## ORIGINATION FORM

Proposed Revisions to a Standard Plans Index  
(Please provide all information — Incomplete forms will be returned)

Index Number: 102-200

Index Title: Temporary ACROW 300 Series Bridge General  
Notes & Details +

LAST REVISION 11/01/18	REVISION	DESCRIPTION:	 <b>FY 2020-21 STANDARD PLANS</b>	<b>TEMPORARY DETOUR BRIDGE GENERAL NOTES AND DETAILS</b>	INDEX <b>102-200</b>	SHEET <b>1 of 7</b>
---------------------------	----------	--------------	---	--	-------------------------	------------------------

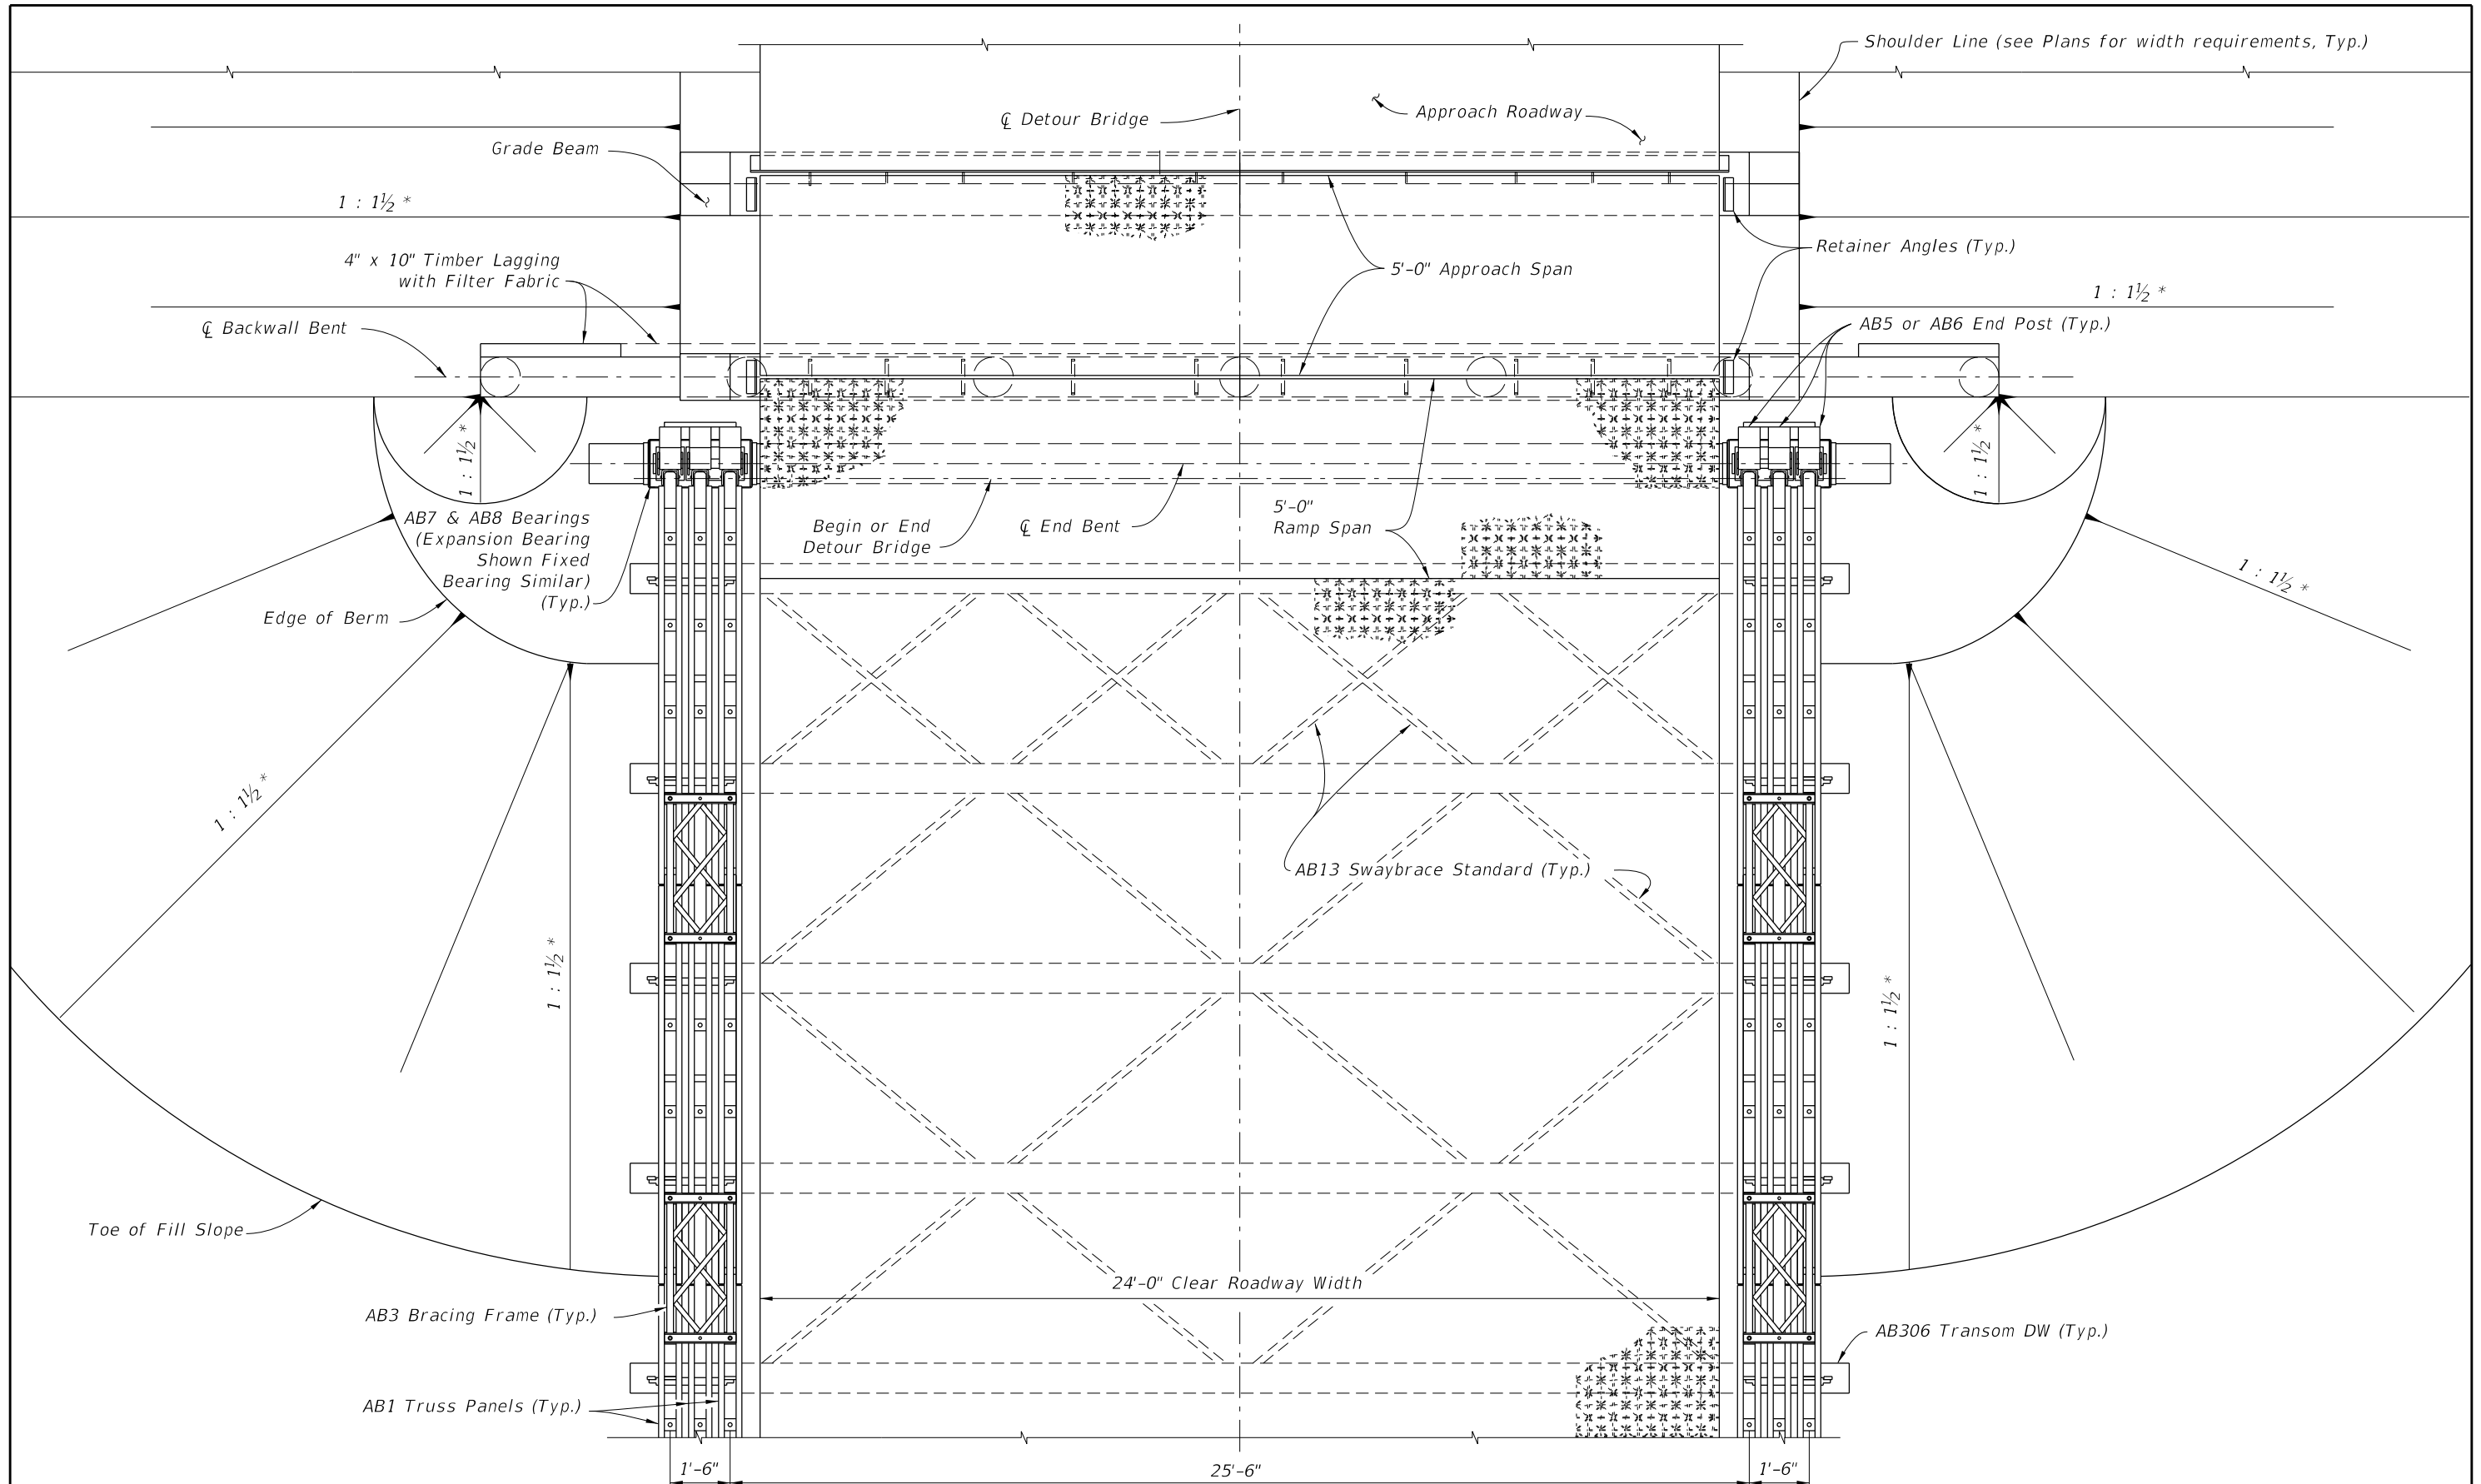
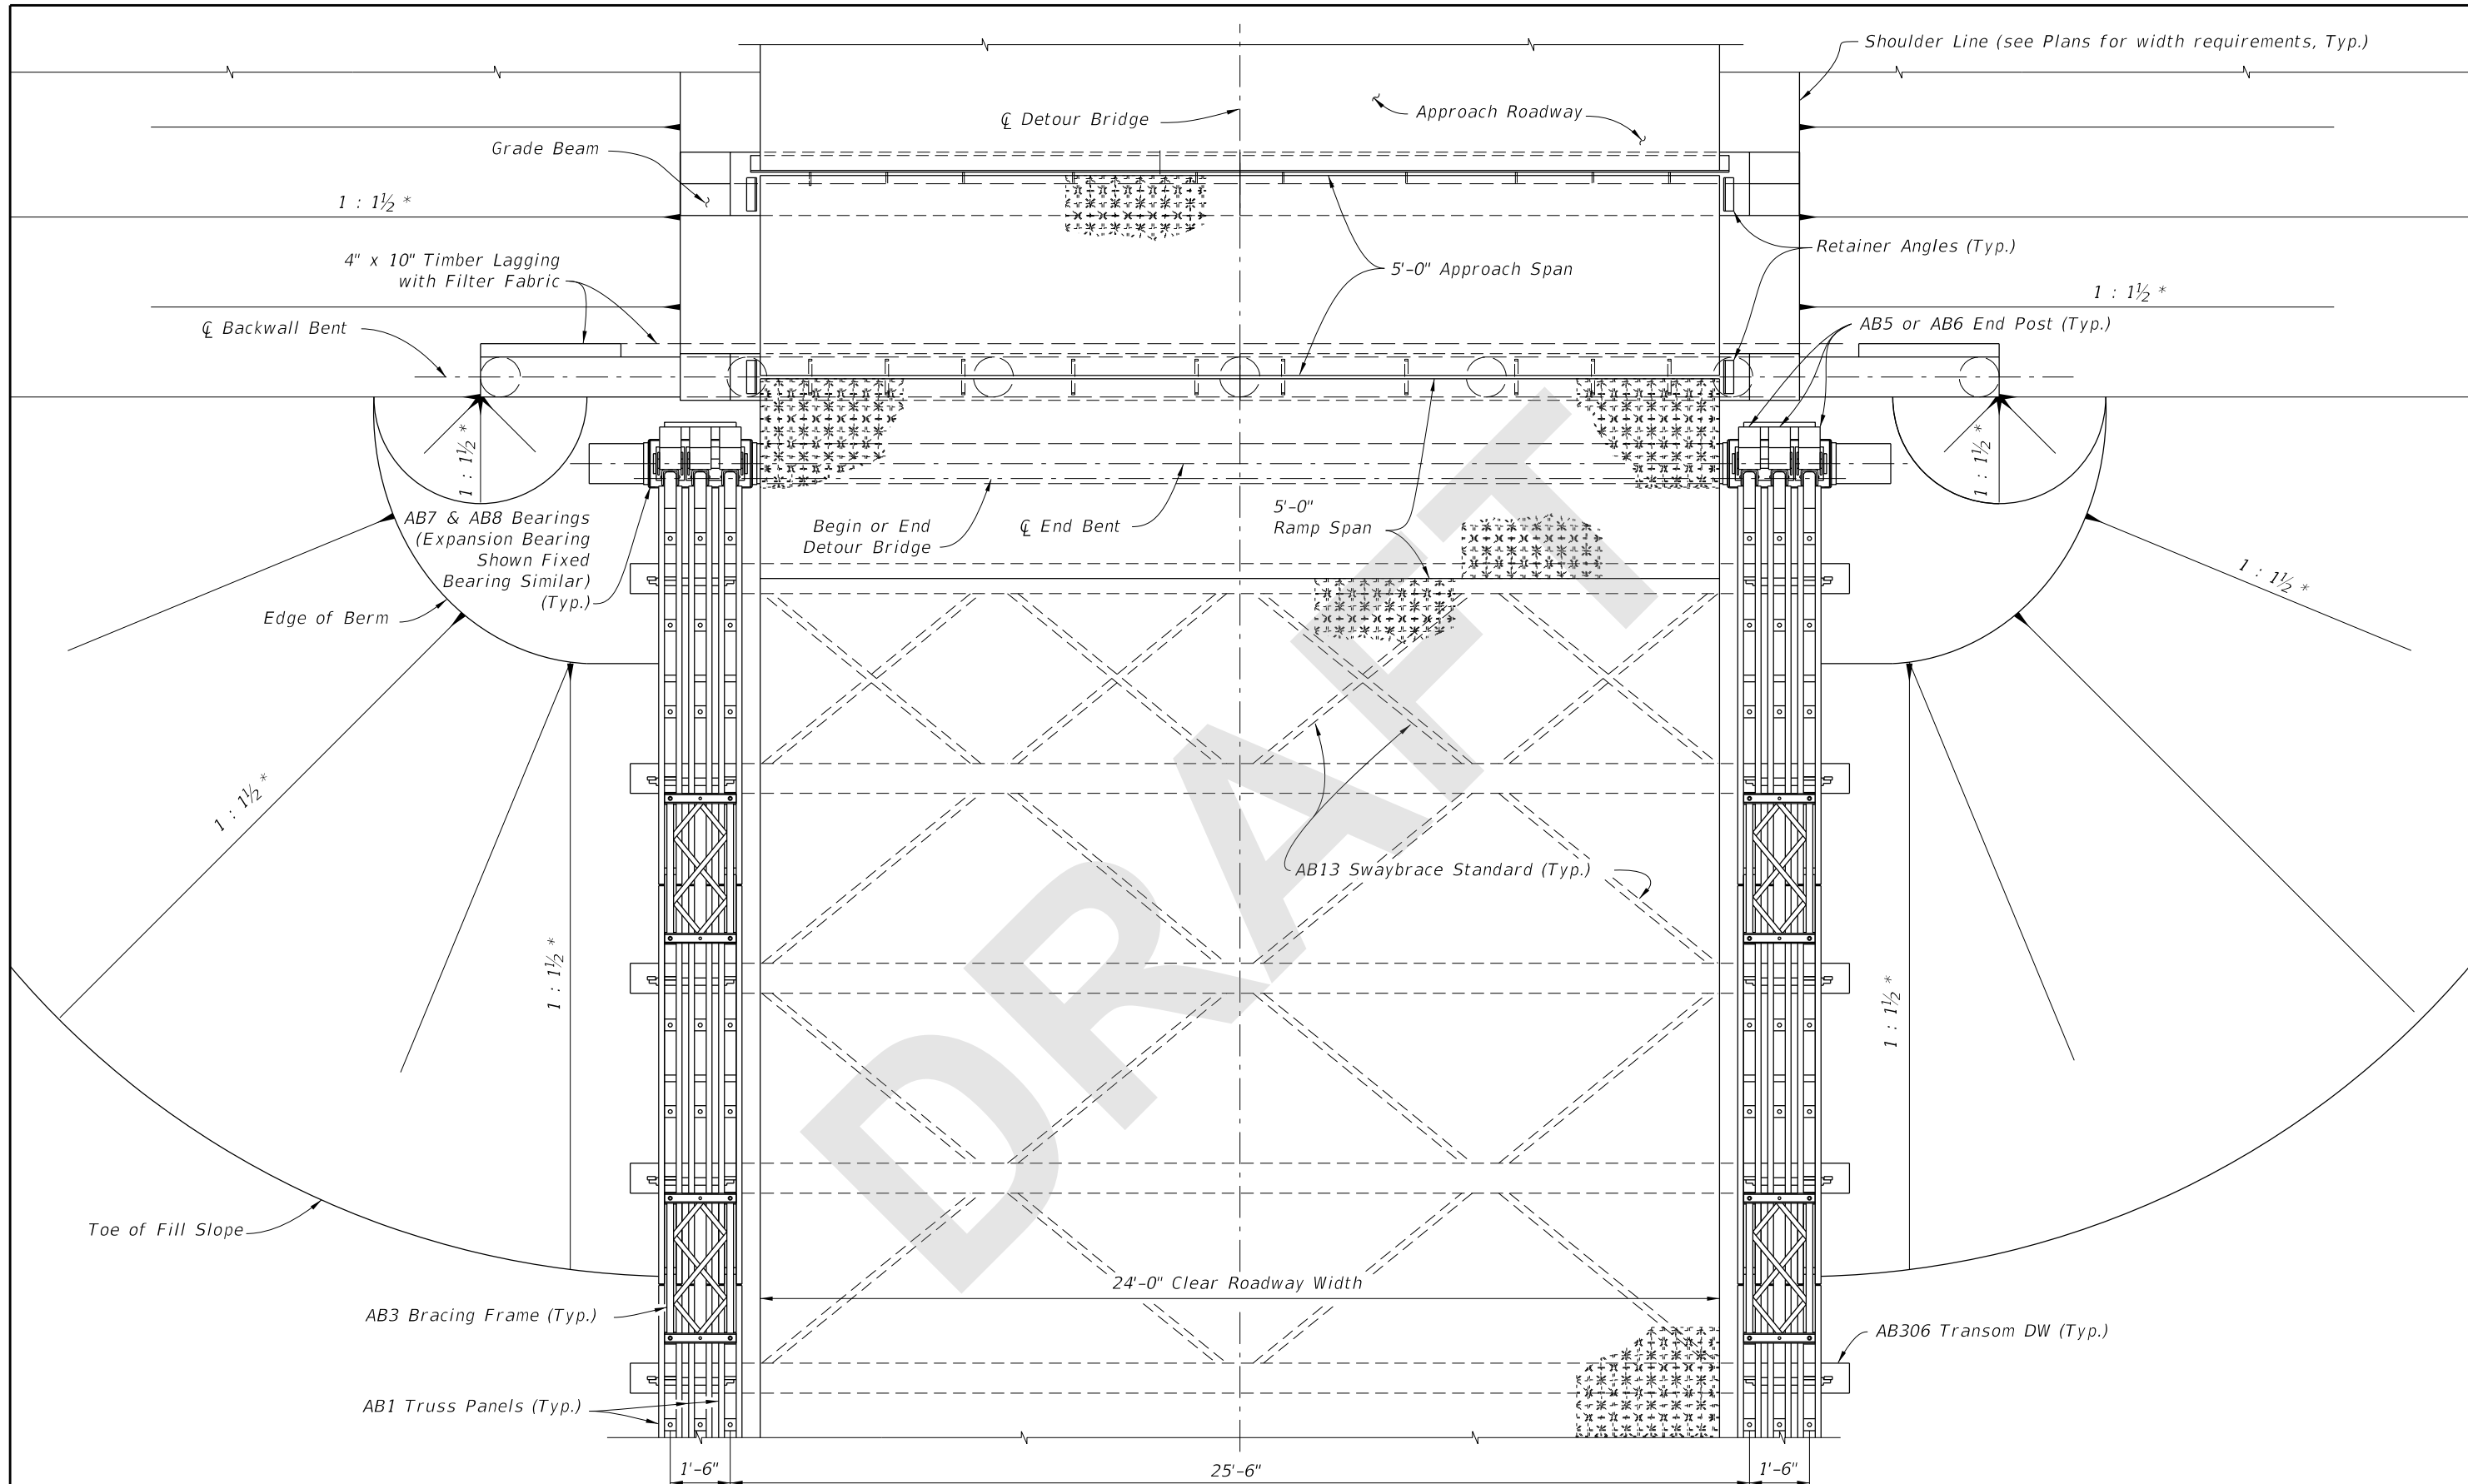
Changed Title to Include 300 Series

LAST REVISION 11/01/20	REVISION	DESCRIPTION:	 FY 2021-22 STANDARD PLANS	TEMPORARY ACROW 300 SERIES DETOUR BRIDGE GENERAL NOTES AND DETAILS	INDEX 102-200	SHEET 1 of 7
---------------------------	----------	--------------	---	---	------------------	-----------------
